Subject: River Bend Station Submittal of Formal NRC Examination Comments
River Bend Station - Unit 1
Docket No. 50-458

In accordance with NUREG-1021, Revision 7, Supplement 1(ES-402, Attachment 3), enclosed are four questions submitted for your review and consideration. The enclosed questions (and supporting documentation) are a result of the NRC administered licensing examination conducted at the River Bend Station the week of August 18, 1995. The chief examiner during the examination was Mr. Howard Bundy.

Figure 12

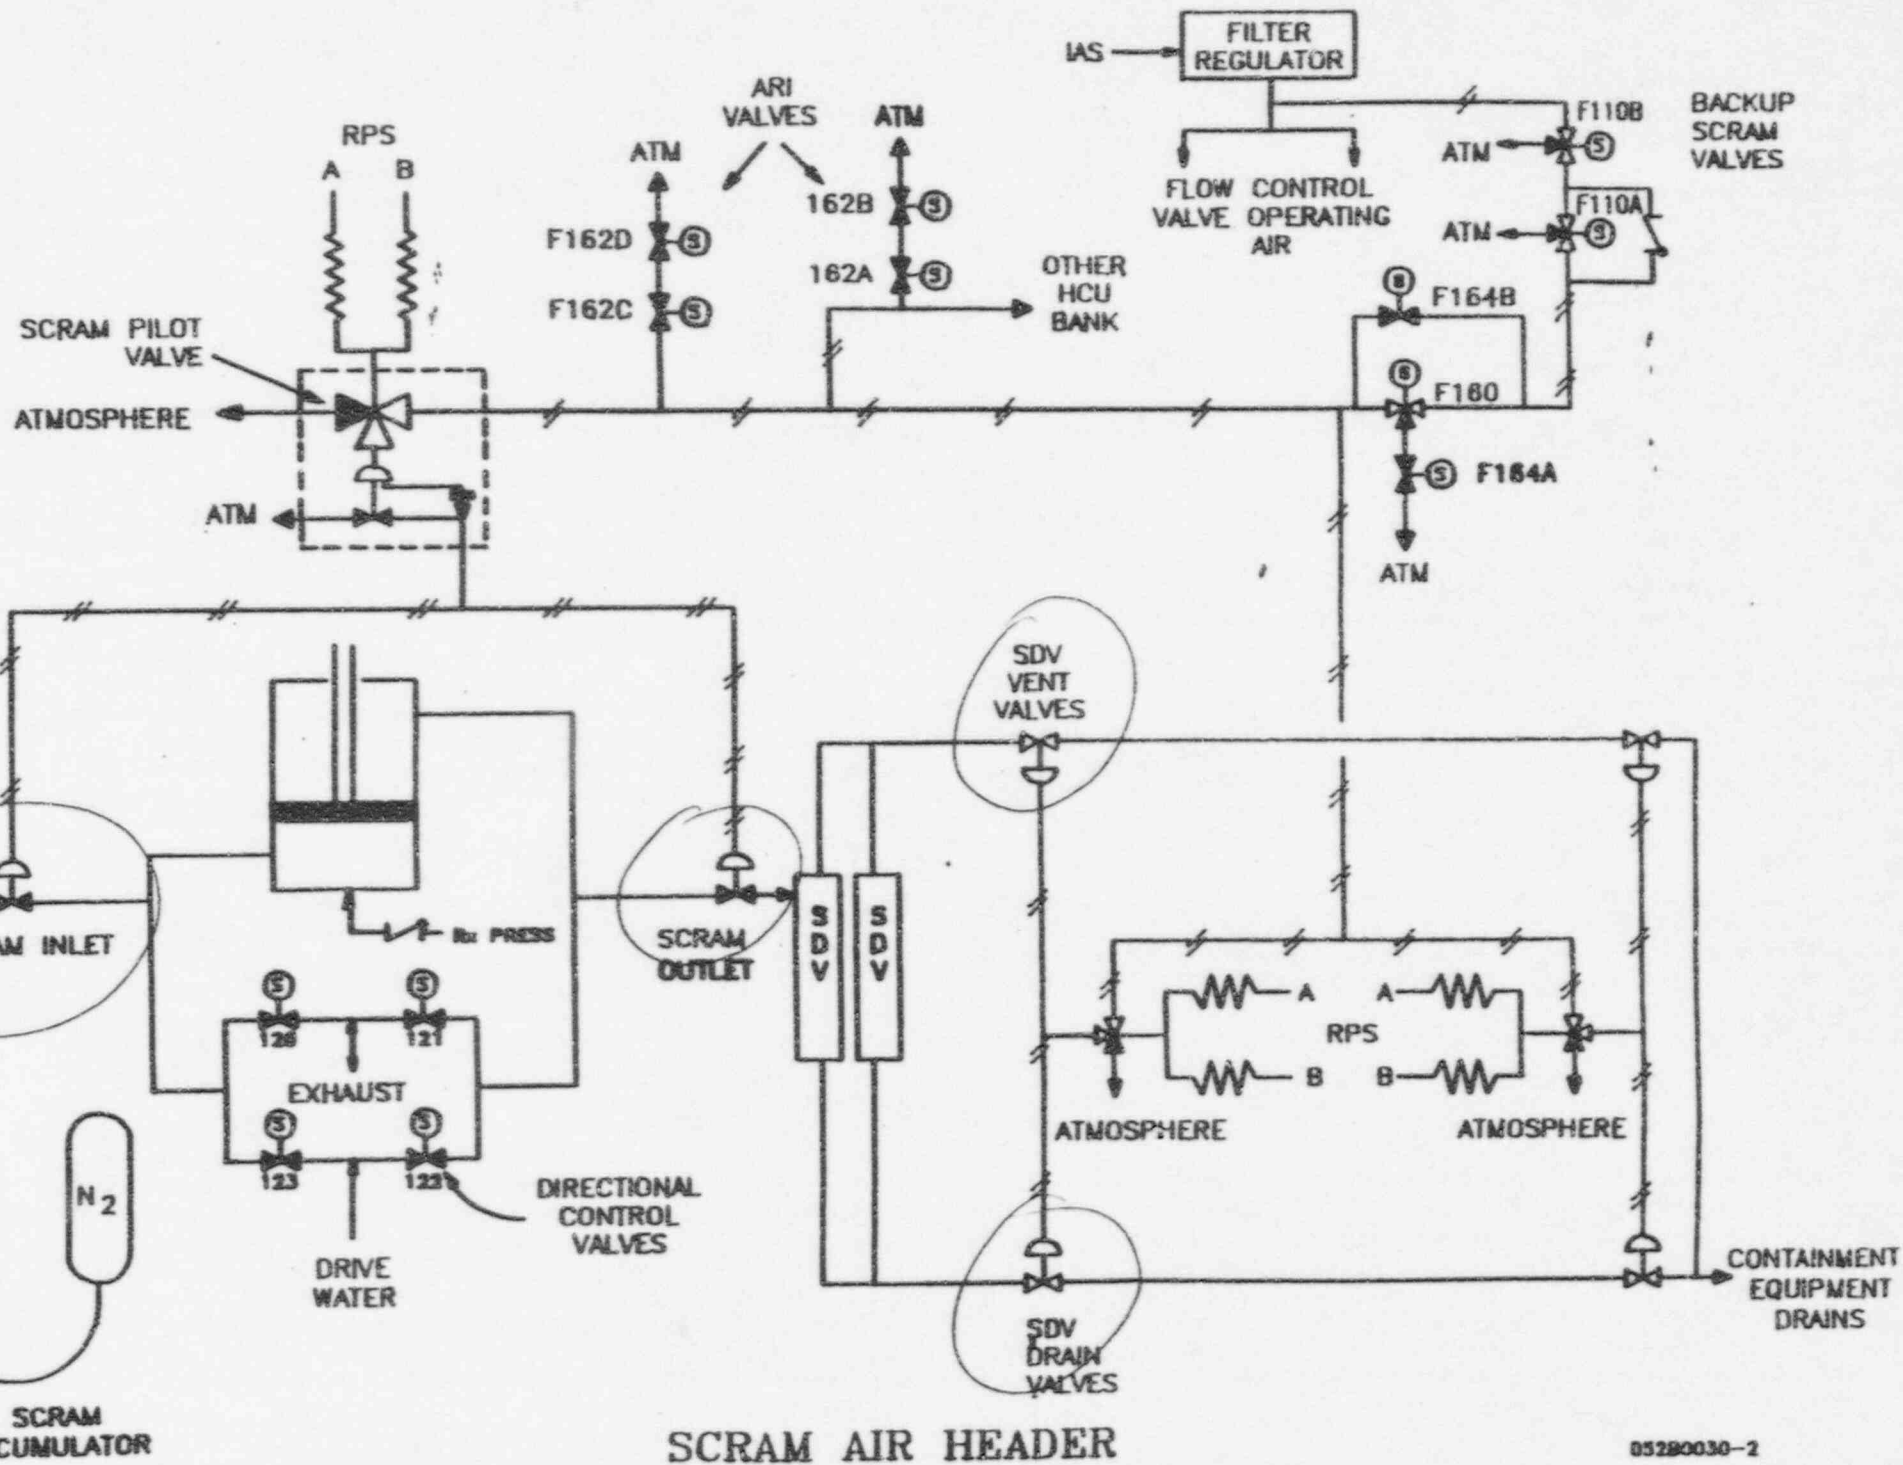
The words "will not eventually" leaves this question with no correct answer. Answer (a) does not send a direct RPS trip but will eventually cause a feedpump trip and eventually a RPV level 3 scram (see AOP-0008, Rev. 7A page 3 of 16, section 3.2). Answer (b) will cause the feedwater regulating valves to lock up and fail "as is". Changes in power, pressure, temperature, and other non-constant external and internal forces (even fuel depletion) will cause a steam flow to feed flow mismatch and you'll get either a high or low RPV level scram. Also the air pressure that is locked up, keeping the feedwater regulating valves in a steady, constant position, will eventually bleed slowly. Answer (c) will result in a loss of condenser vacuum which does not send a direct RPS trip but will eventually cause a turbine trip and a resultant Rx scram (see AOP-0008, Rev. 7A page 3 of 16, section 3.5). Answer (d) will cause the rods to go in, and will cause either the scram discharge volume to fill faster than it can drain (assuming that the scram discharge volume vent & drain valves did not fail closed since the air line is common to the scram inlet and outlet valves which lost air) and cause a RPS scram or because the turbine is on the line and Rx power level is going down due to rods going in will cause Rx pressure to go below 849 psig (eventually because of other steam loads) and cause the MSIV's to go closed and cause a RPS scram (see LOTM-5 Fig. 12, Tech.Spec table 2.2.1-1(6)&(9), pages 2-4&5, and Tech.Spec table 3.3.2-2(2.c), page 3/4 3-19).

Throw out the question since there is no correct answer.
